SITE PLANS & GENERAL NOTES
FOR GUARDRAIL CONNECTION
AT VARIOUS STRUCTURES

FARRINGTON HIGHWAY RESURFACING
Ulehana Stream Towards Pili-o-koe Bridge
F.A. Proj. No. F-093-1(7)

TYPICAL DETAILS
GUARD RAIL CONNECTION
TO EXIST. END POST
FARRINGTON HWY RESURFACING
ULEHAWA STREAM TOWARDS PILIOKOE BRIDGE
F.A. Proj. No. F-023-1(2)
Scale: As Noted Date:

EXISTING END POST DIMENSION SCHEDULE

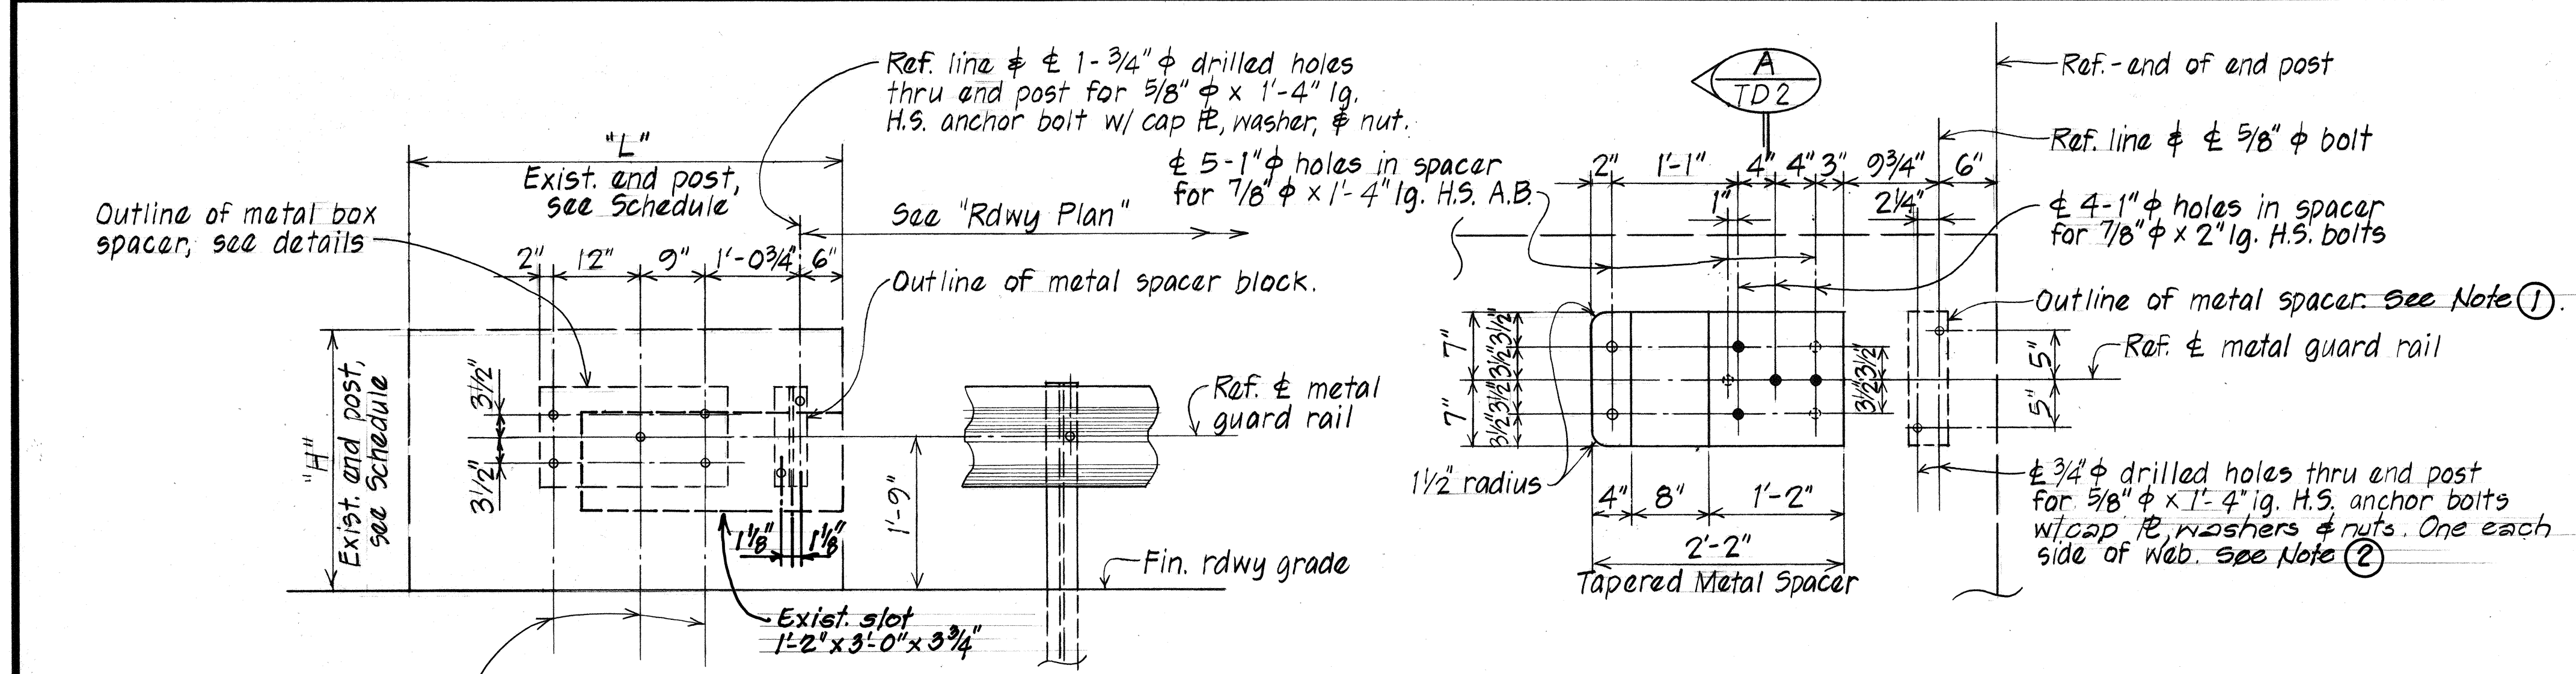
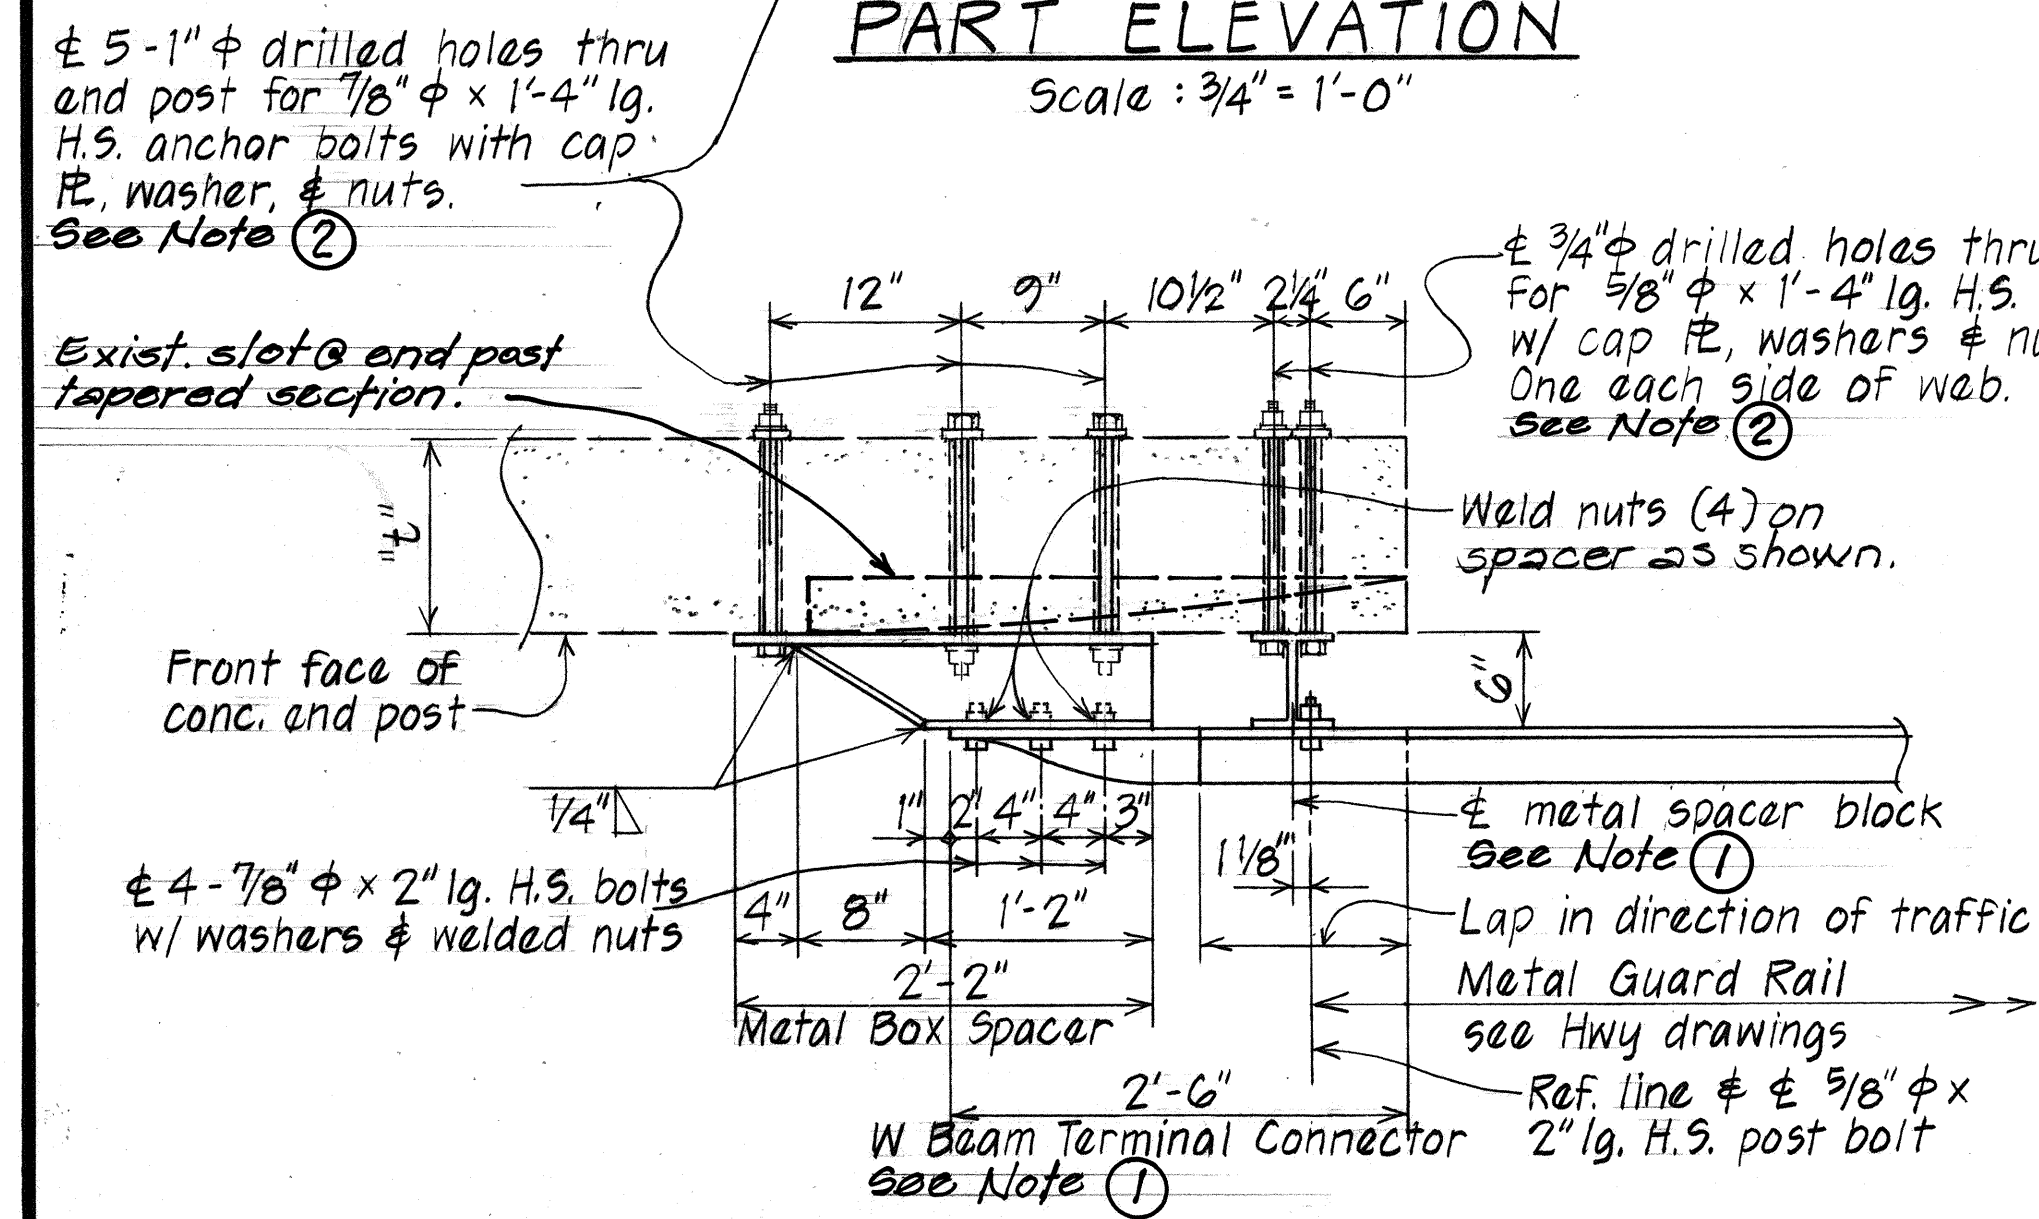
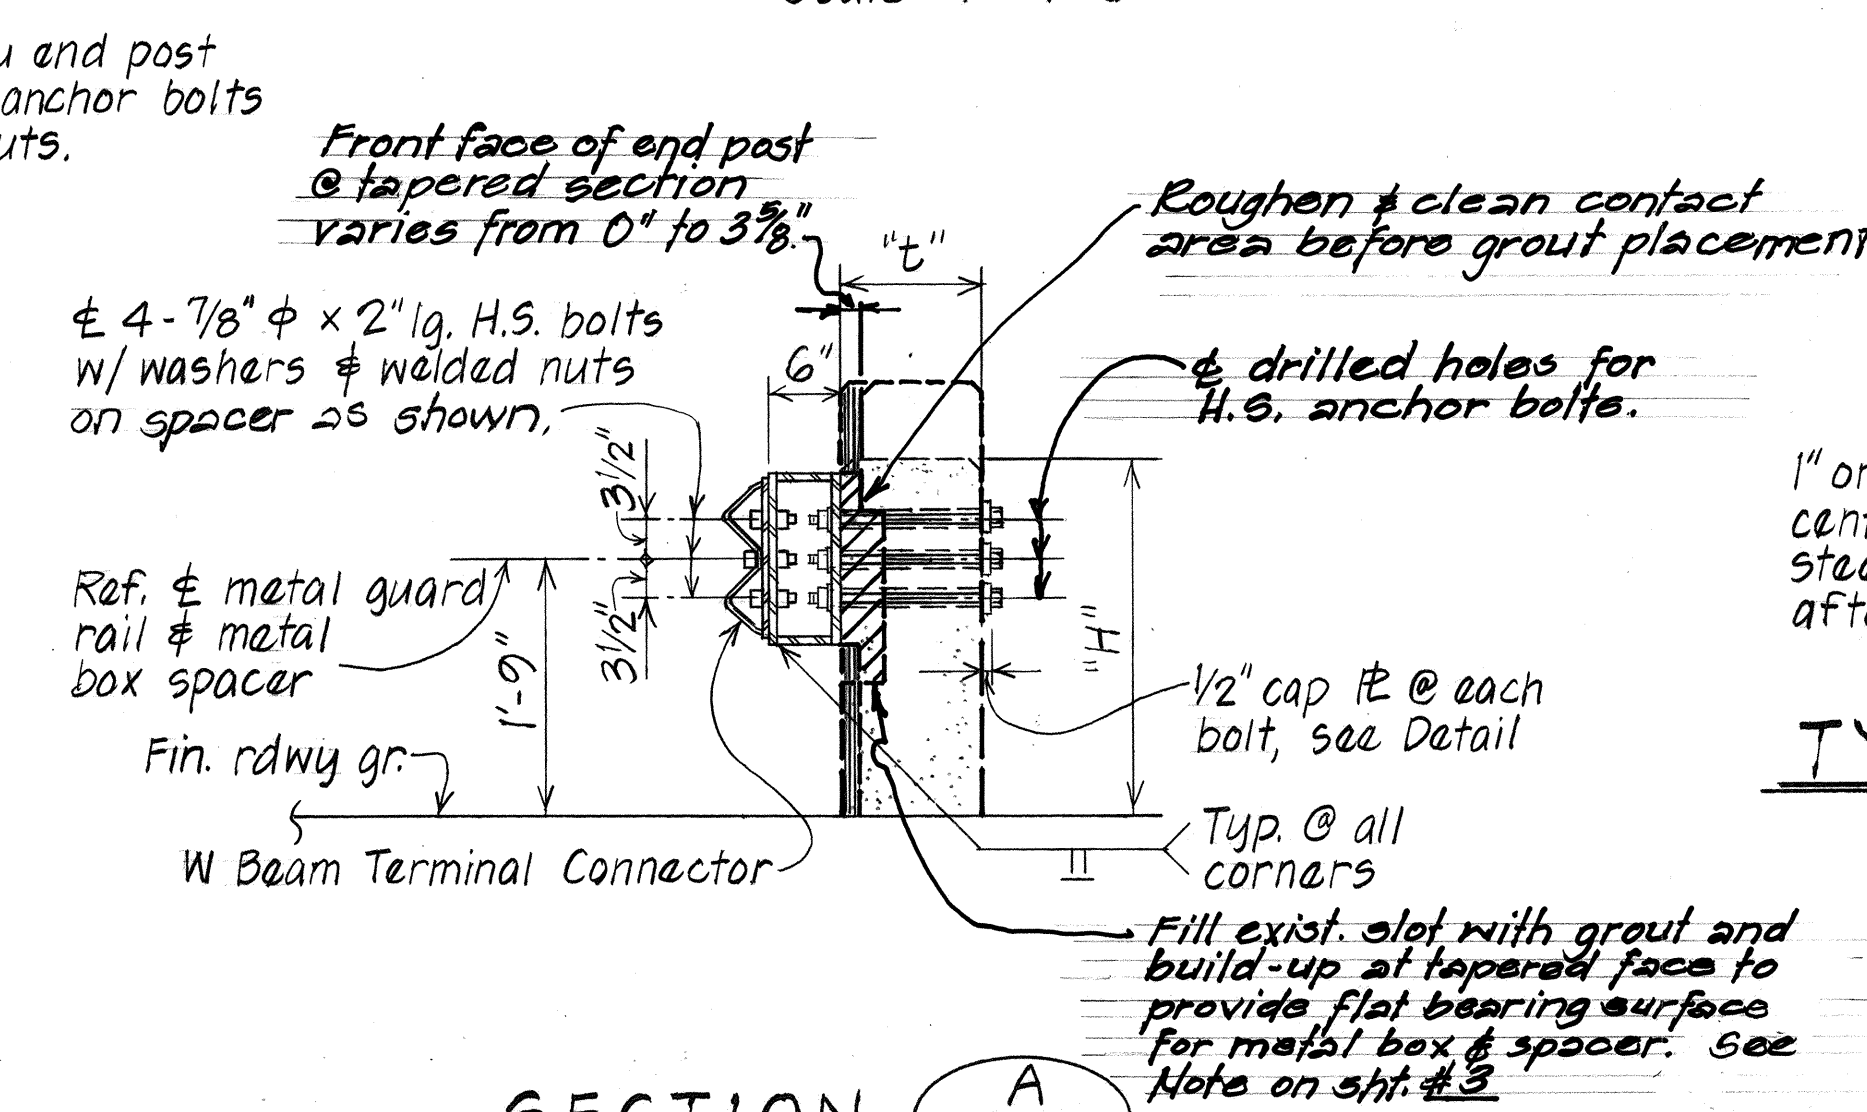
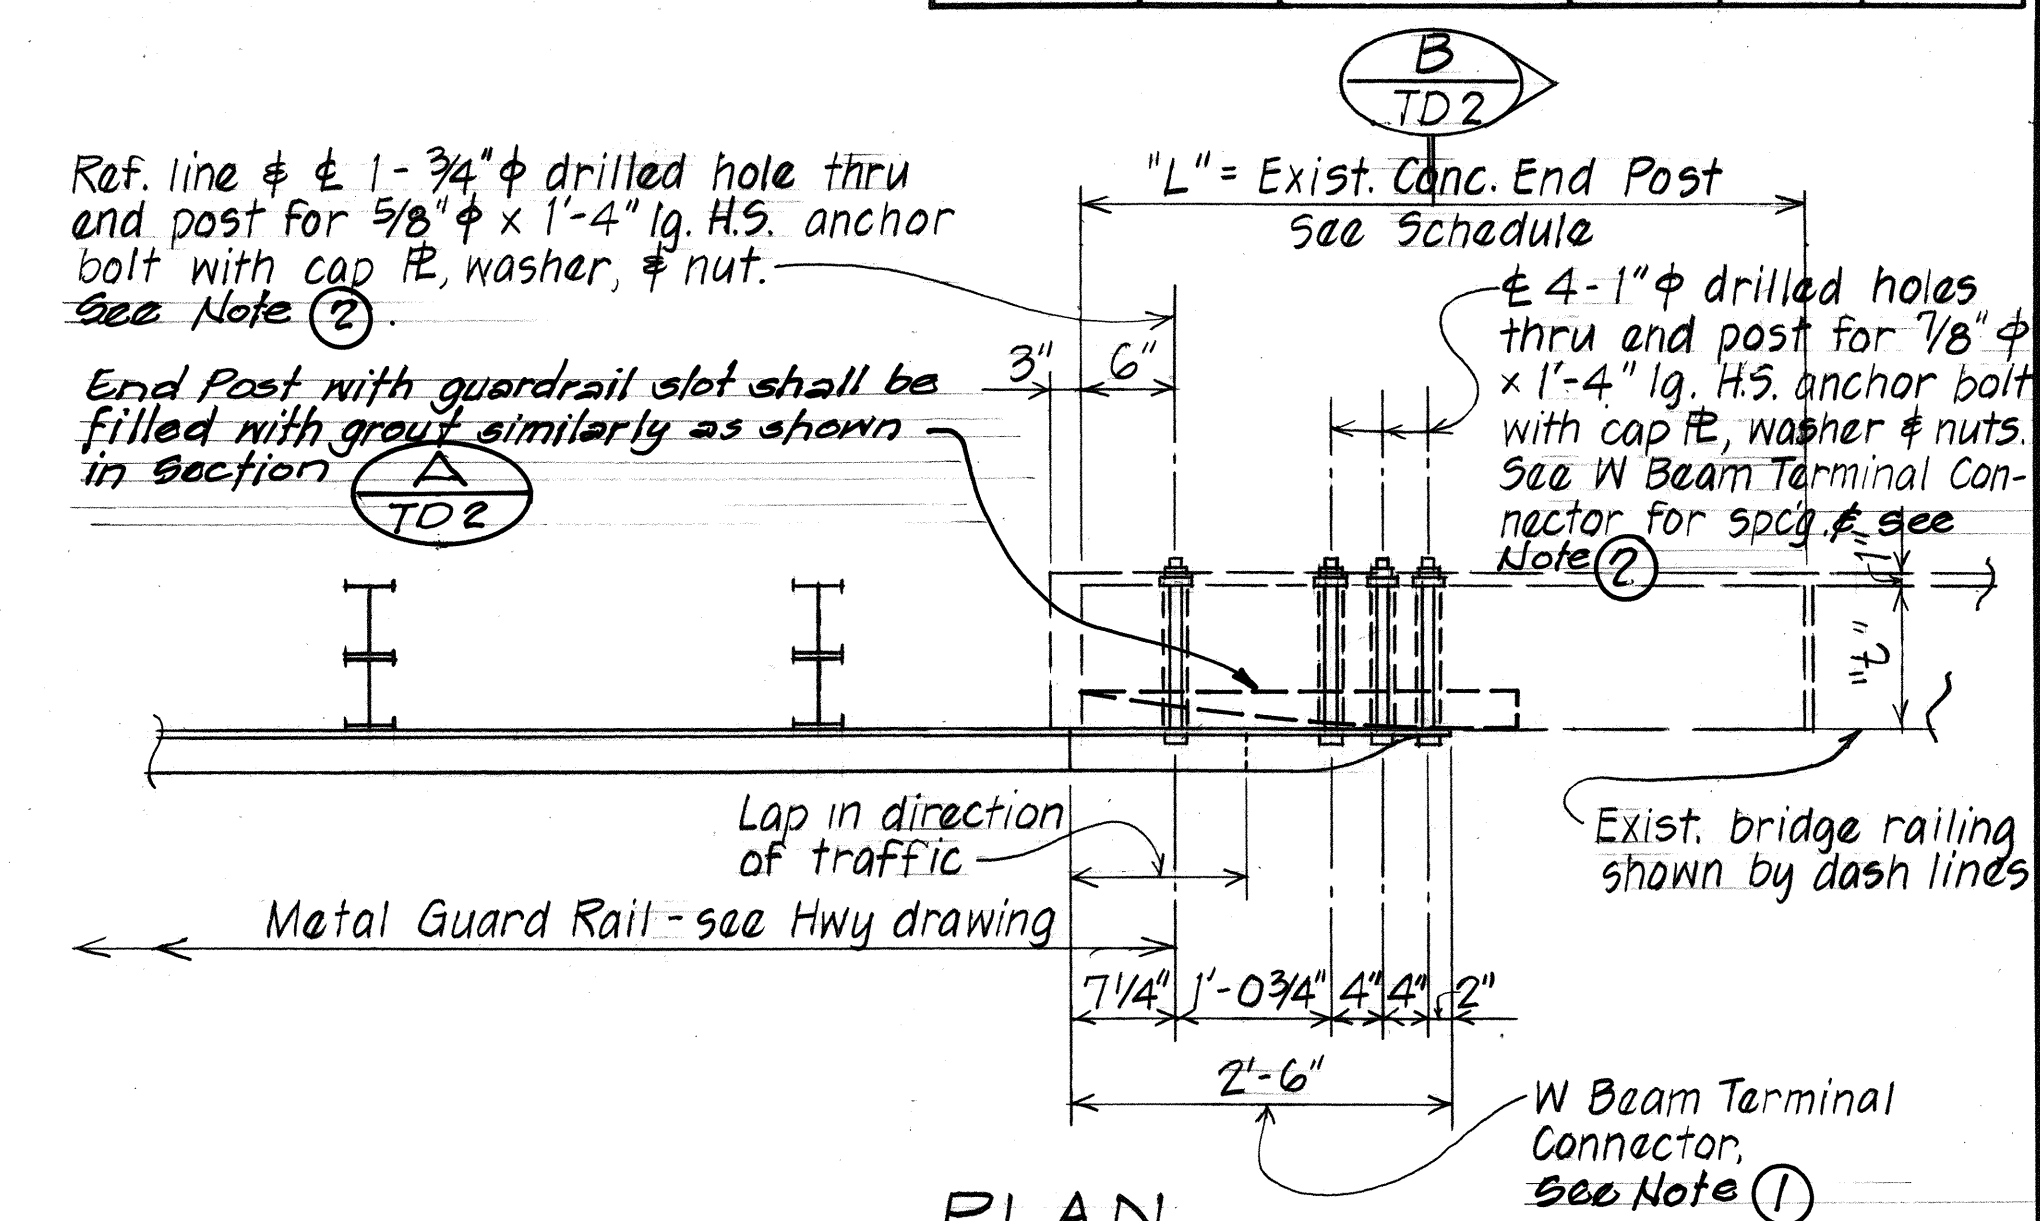
The words "Mauka" and "Makai" deleted from EXISTING END POST DIMENSION SCHEDULE per Addendum No. 1.
